**PSE&G** Public Service  
Electric and Gas  
Company

August 20, 1984

HOPE CREEK GENERATING STATION  
DOCKET NO. 50-354  
DRAFT SAFETY EVALUATION REPORT  
OPEN ITEM STATUS

Attachment 1 is a current list which provides a status of the open items identified in Section 1.7 of the Draft Safety Evaluation Report (SER). Items identified as "complete" are those for which PSE&G has provided responses and no confirmation of status has been received from the staff. We will consider these items closed unless notified otherwise. In order to permit timely resolution of items identified as "complete" which may not be resolved to the staff's satisfaction, please provide a specific description of the issue which remains to be resolved.

FIGURE 220.21-25  
 RESPONSE SPECTRA COMPARISON,  
 AUXILIARY BUILDING AT ELEV. 54' -0",  
 E-W, SSE, 2% DAMPING

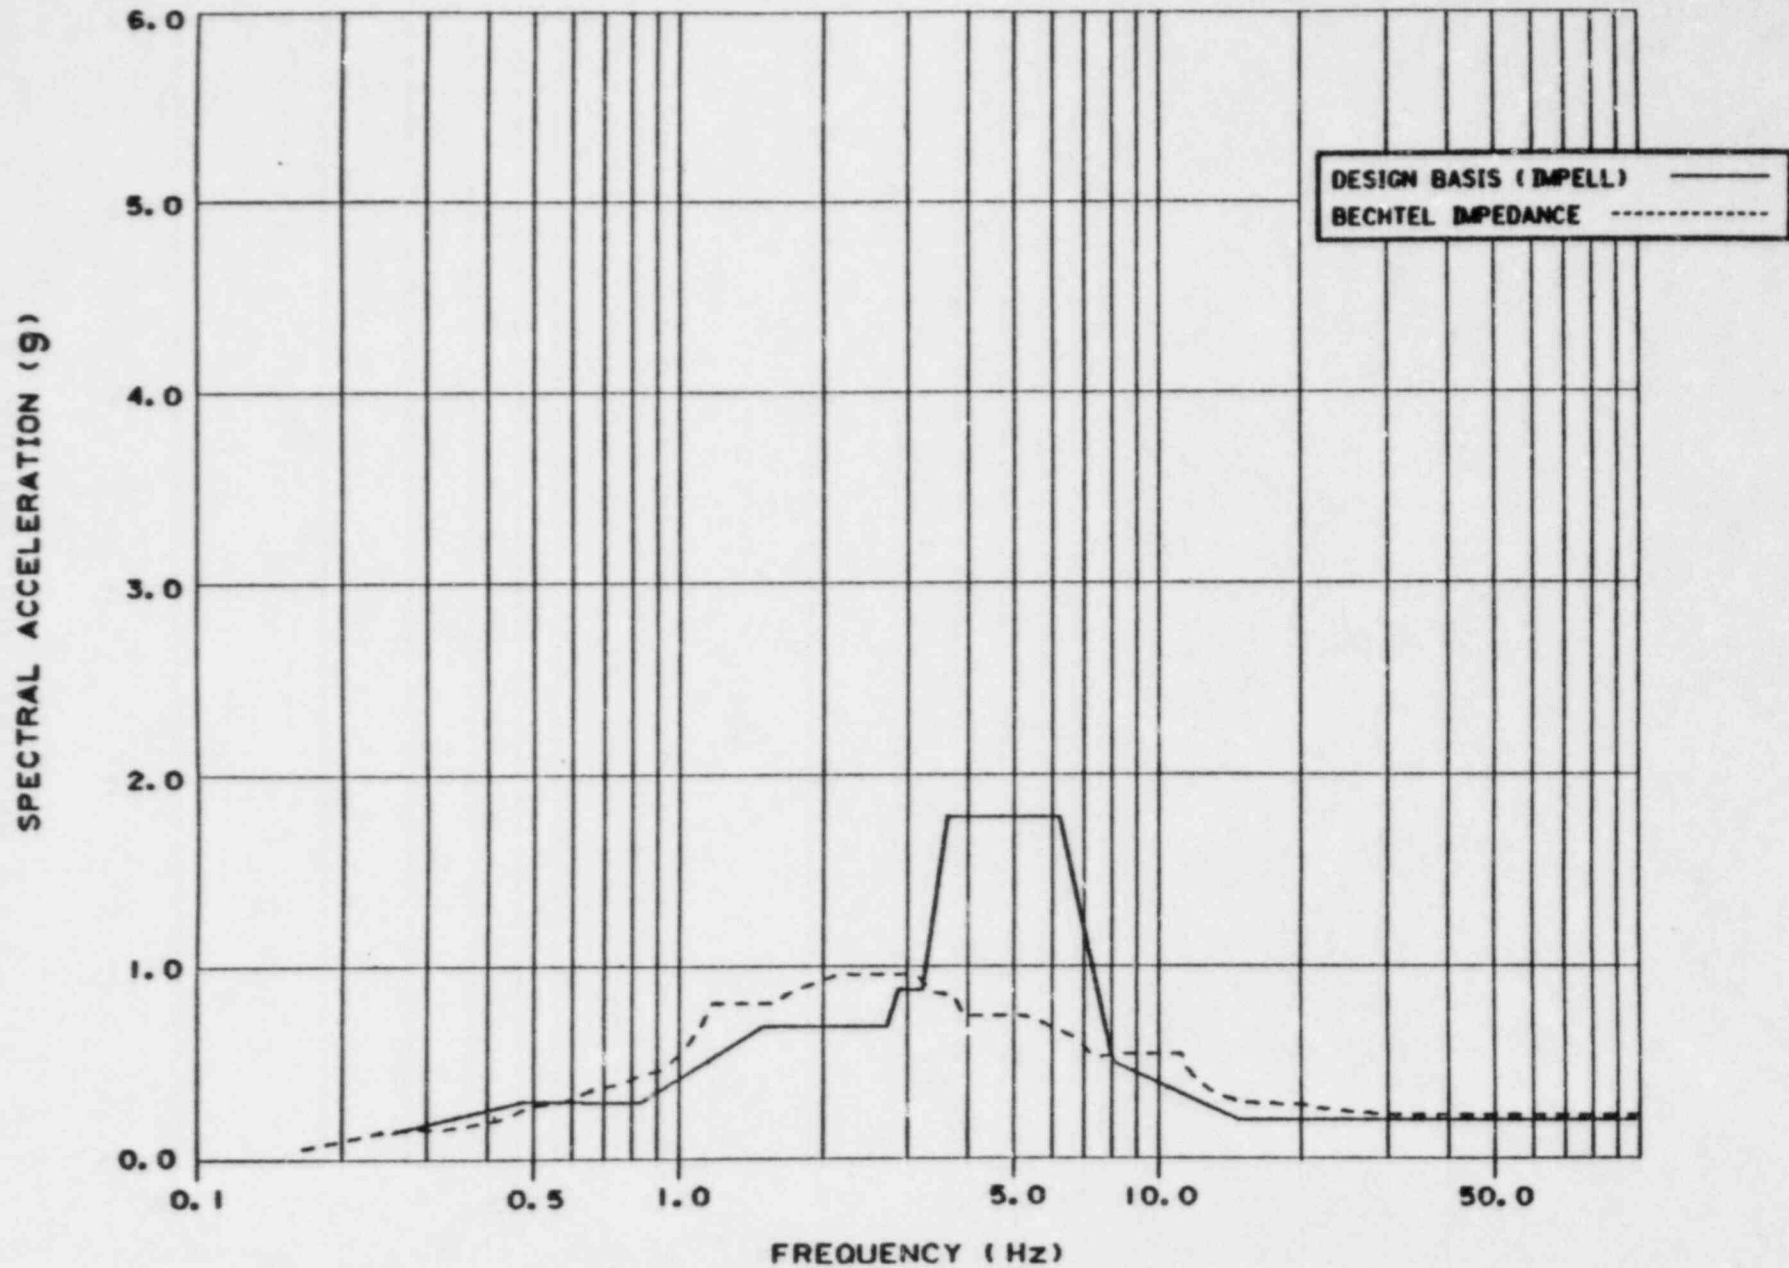
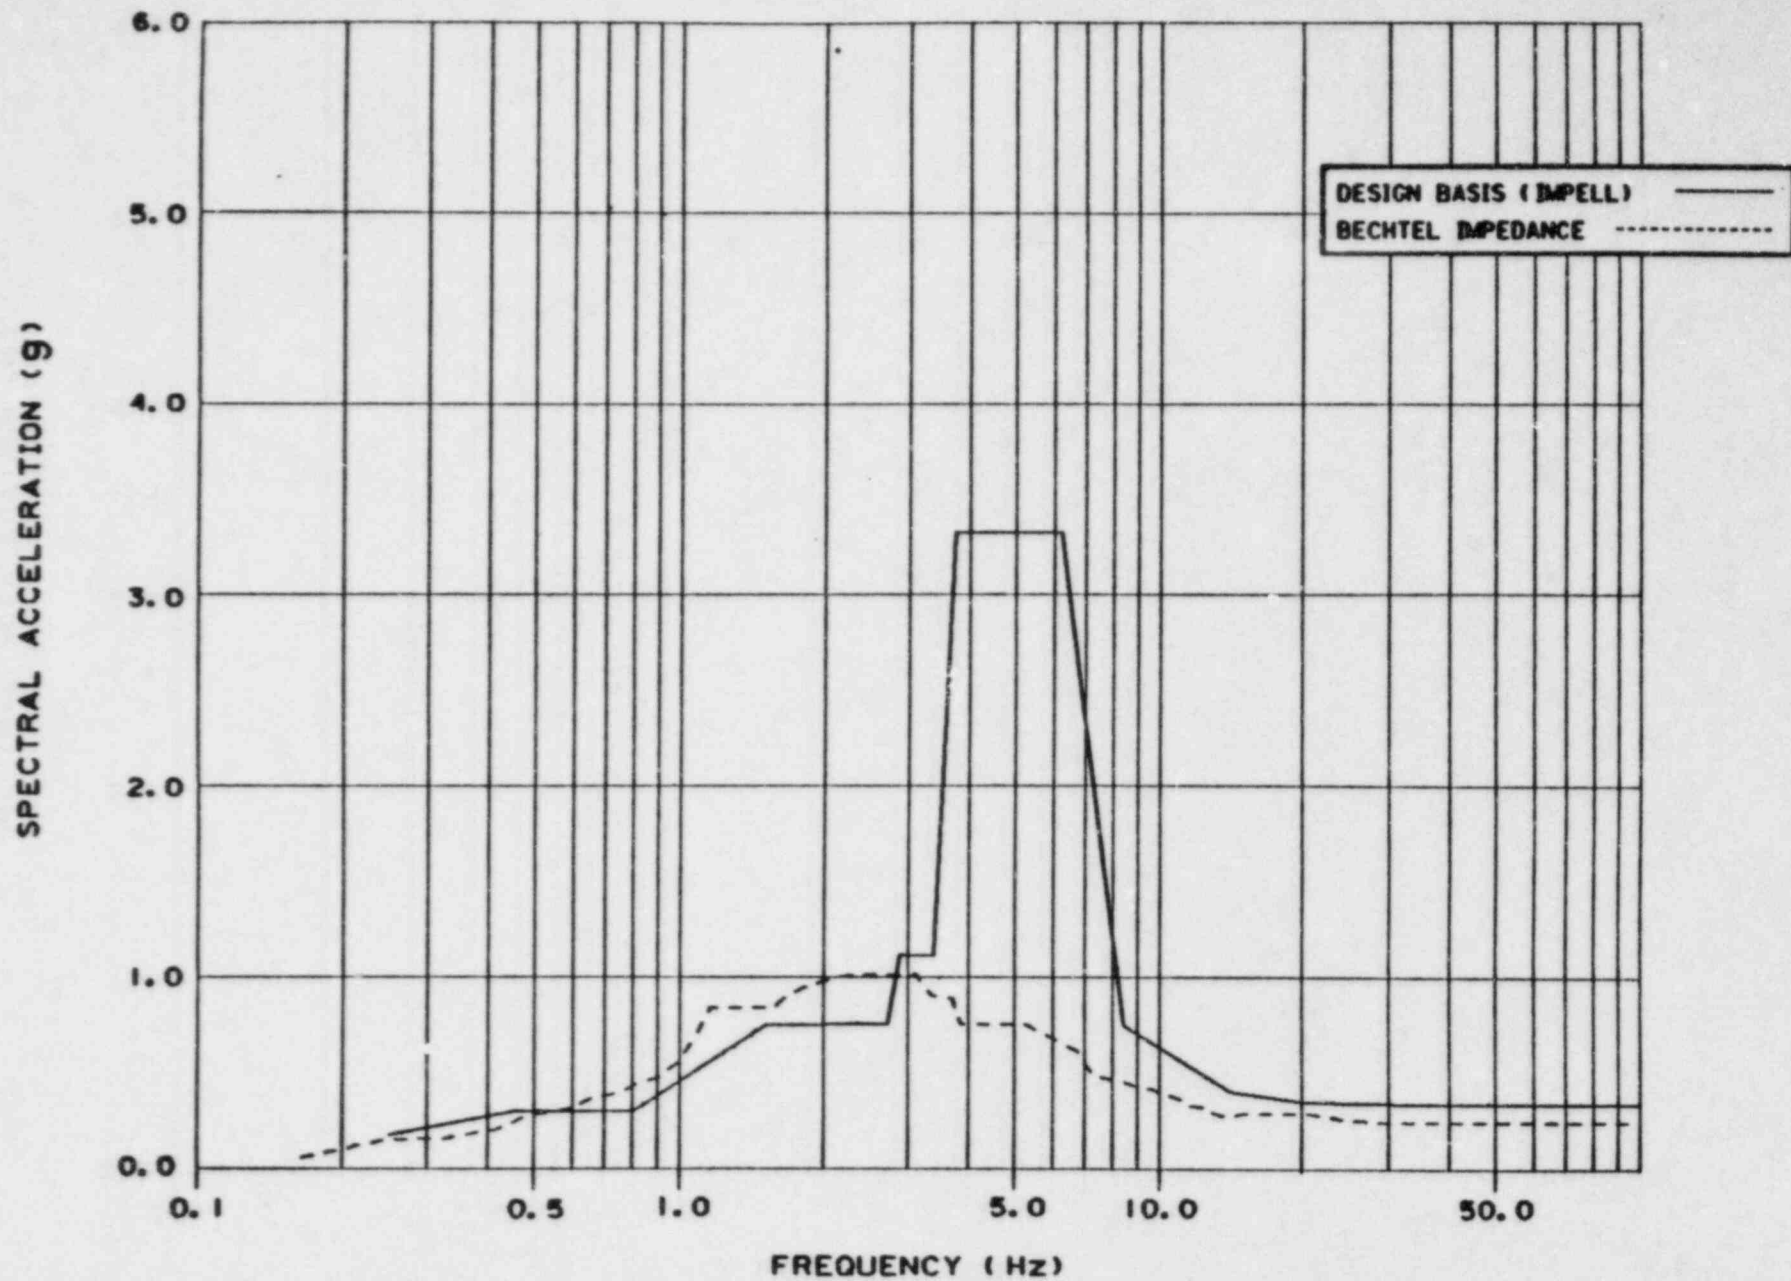
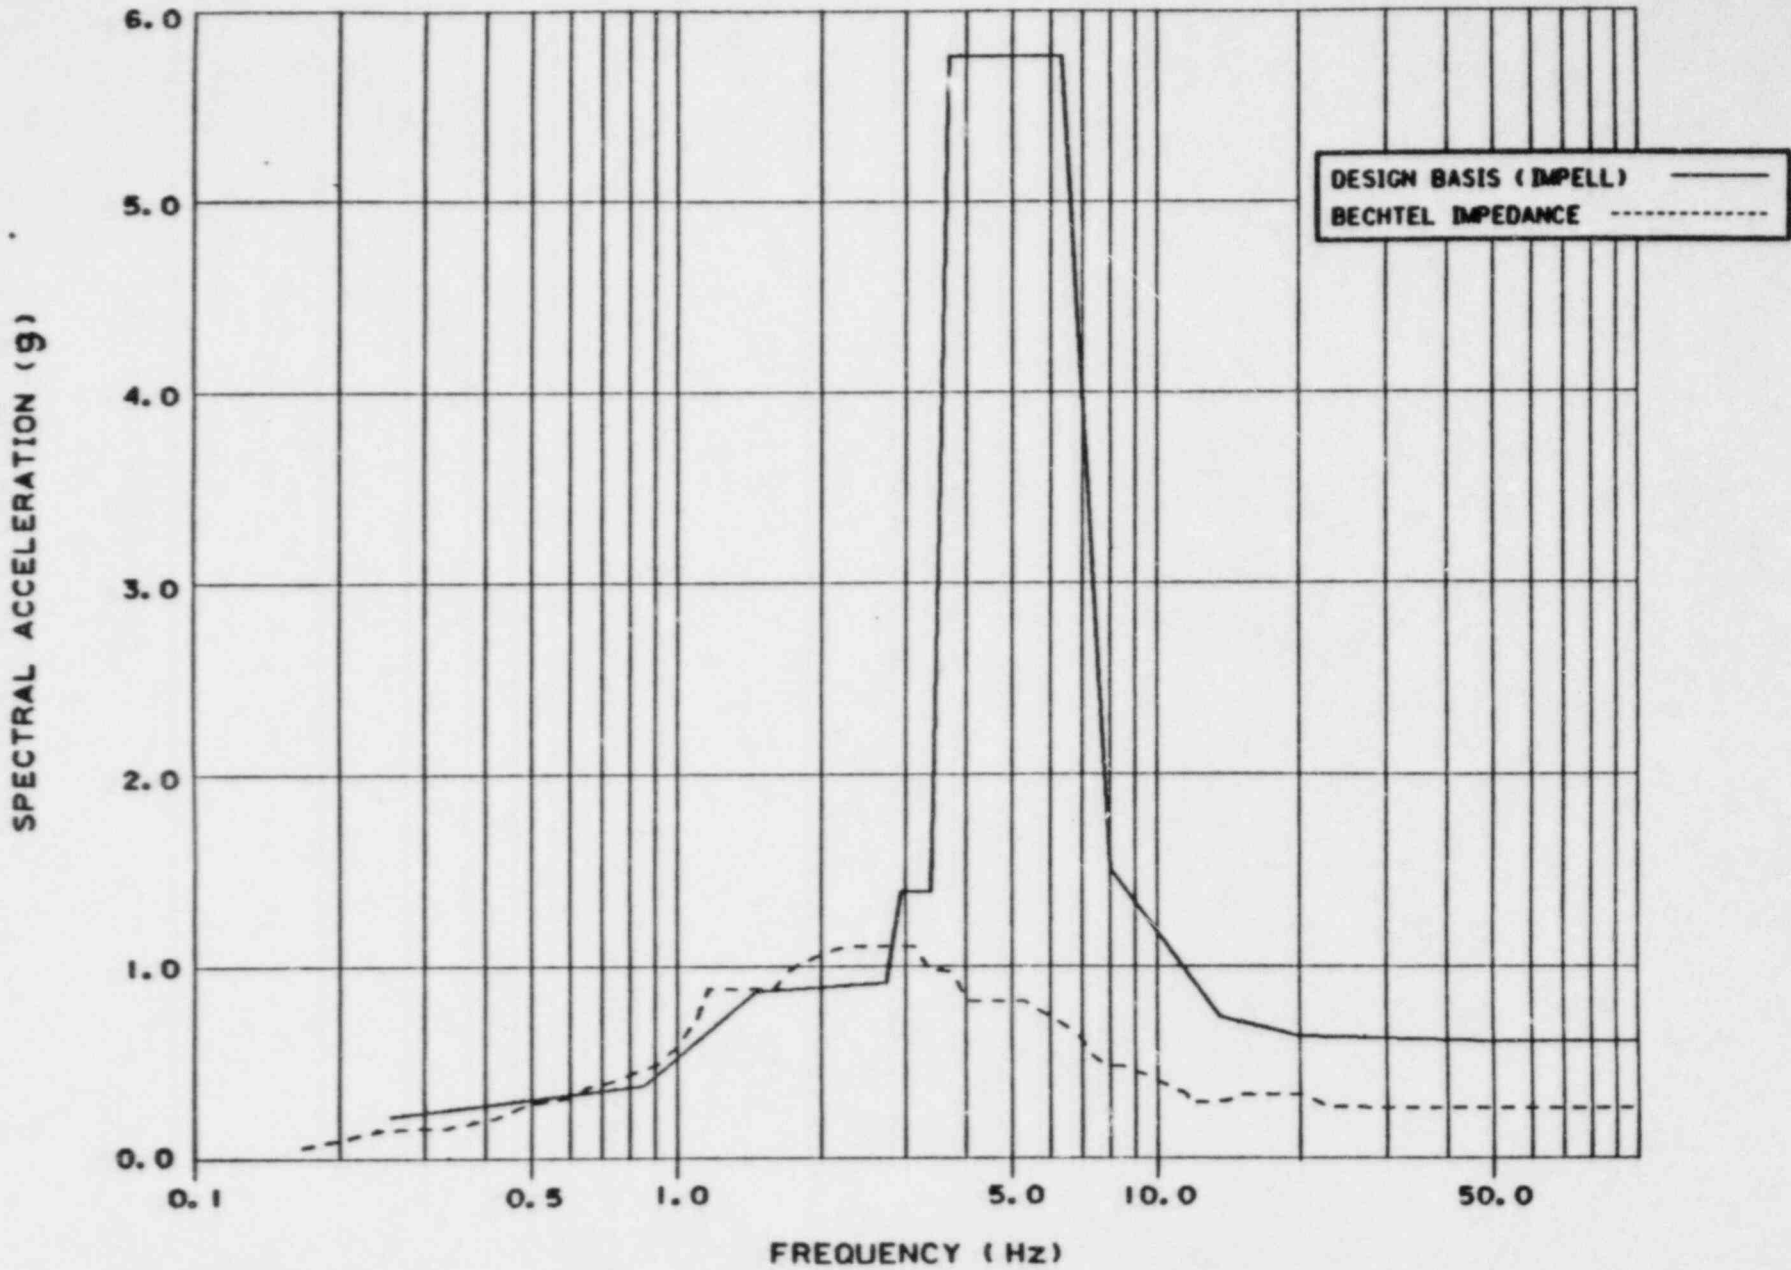
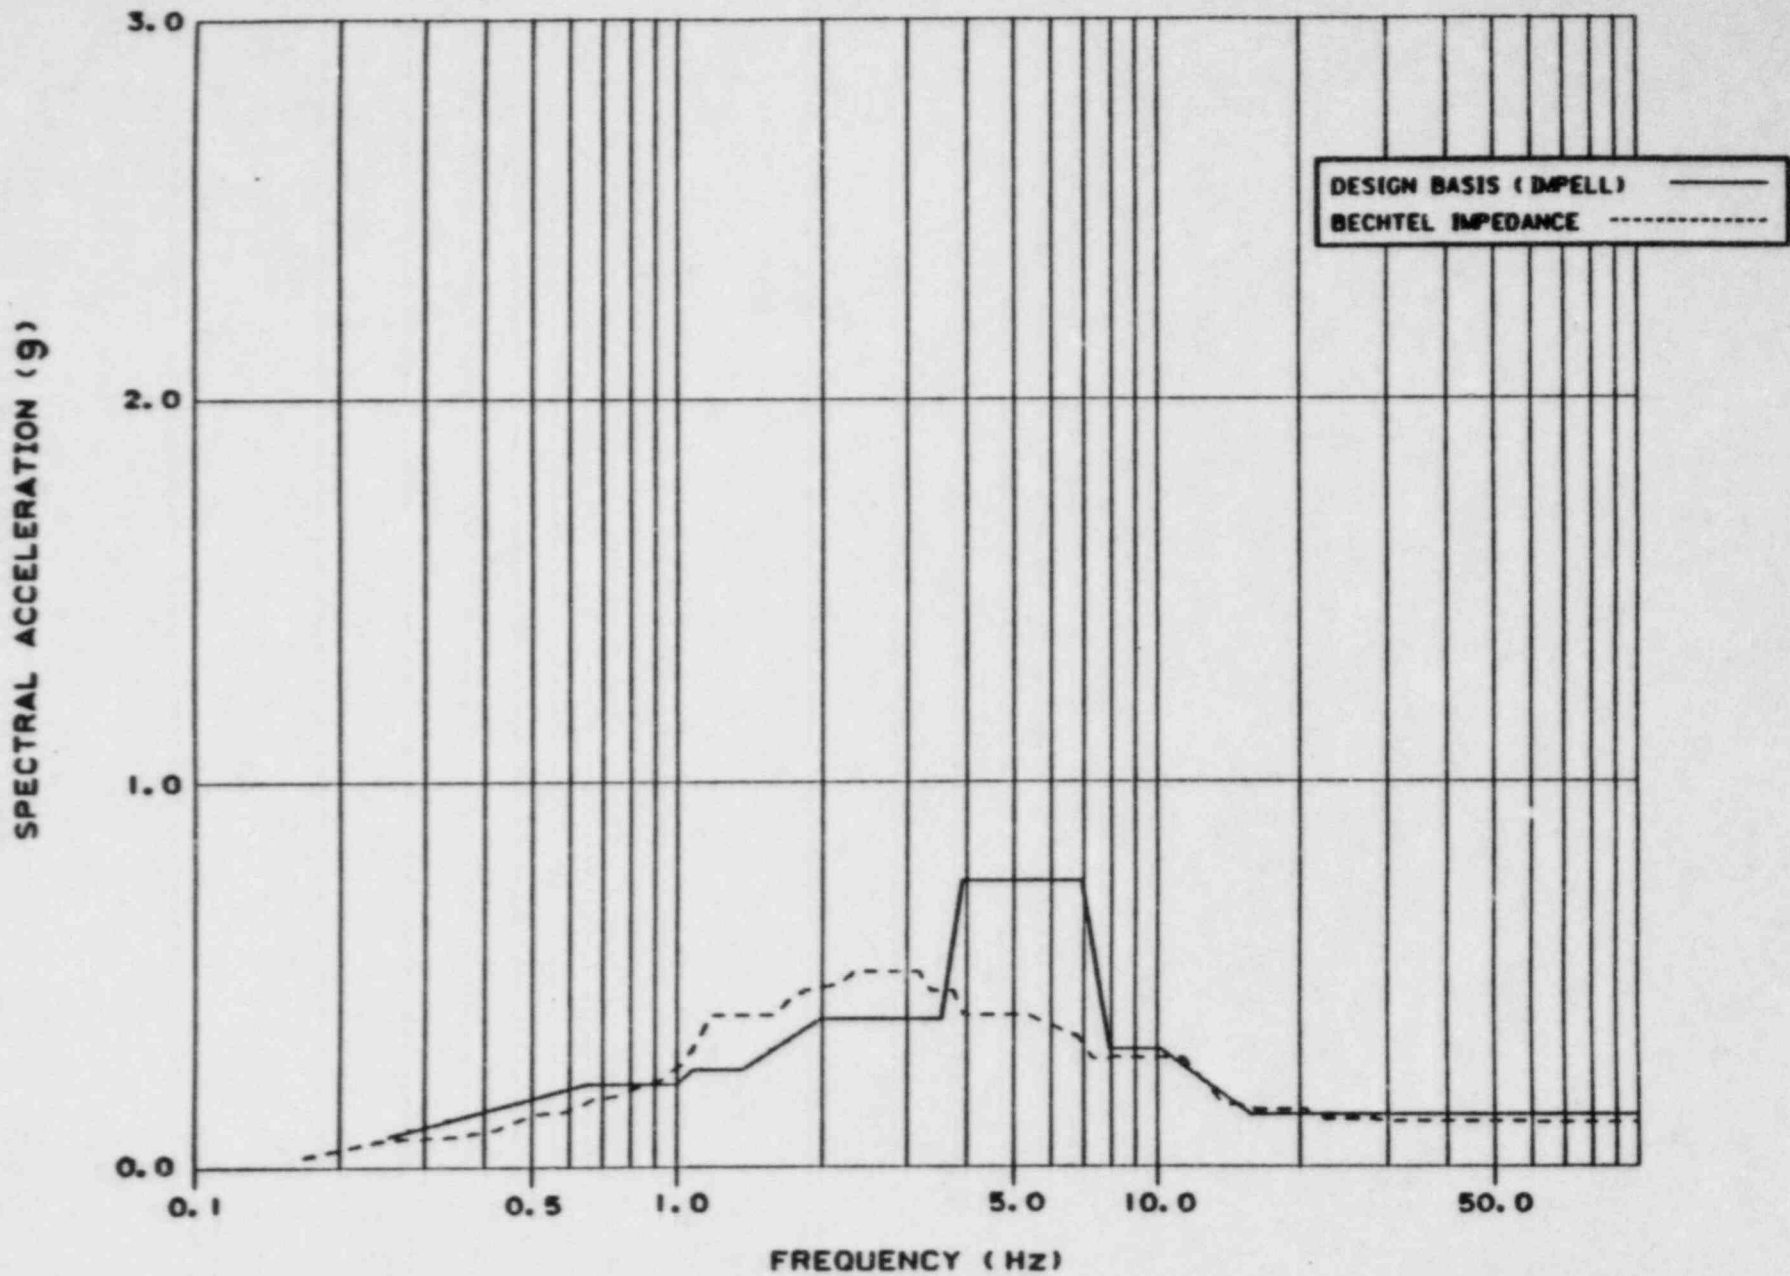
Figures 220.21-1 through 220.21-54 show a comparison of the 2 percent damping response spectra obtained from the design basis finite element and the impedance analyses for the reactor building, auxiliary building and the service water intake structure (SWIS).

¶ For the reactor and auxiliary buildings, the peak spectral accelerations obtained from the impedance analysis are generally lower than those obtained from the design basis analysis. However, the impedance analysis response spectra are not completely enveloped by those obtained from the design basis analysis, especially in the frequency range from 1.0 to 3.5 Hz. Also, there are some local exceedances in the higher frequency range, as shown in Figures 220.21-1 through 220.21-36. ¶ For the SWIS (Figures 220.21-37 through 220.21-54), the impedance analysis response spectra are generally enveloped by those obtained from the design basis analysis at elevation 114.0 feet. For other elevations, the impedance analysis spectral accelerations exceed the design basis spectral accelerations in some frequency ranges. These ranges vary approximately between 1.5 and 10.0 Hz.

In all cases, the items reviewed during these sampling studies can accommodate the loads resulting from the impedance analysis. Therefore, the impedance analysis results have no impact on the plant design.
